General machining tolerances UNI 5307-83								Dimension	< 6	6-30	30-120	120-315	315-1000	1000-2000	> 2000-4000	> 4000	Linear tol.	± 0.1	± 0.2	± 0.3	± 0.5	± 0.8	± 1.2	± 2	± 3	Angular tol.	± 1'	± 30'	± 20'	referred to the shortest side				
General machining tolerances UNI 5307-83																																										
Dimension	< 6	6-30	30-120	120-315	315-1000	1000-2000	> 2000-4000	> 4000																																		
Linear tol.	± 0.1	± 0.2	± 0.3	± 0.5	± 0.8	± 1.2	± 2	± 3																																		
Angular tol.	± 1'	± 30'	± 20'	referred to the shortest side																																						
				designed by <b>R. De Salvo</b> G. Gennaro-PROMECC																																						
title <b>HAM-OPTICAL BENCH</b> DETAIL MOUNTING BLADE				date 28-01-05 scale 1/1																																						
sheet 144				page A 1

81.1

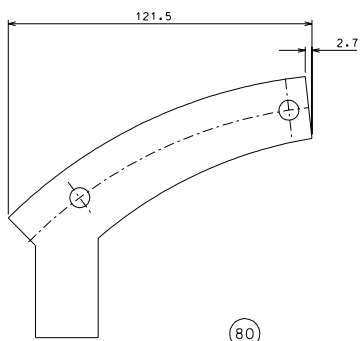
copy the missing dimensions from detail 81
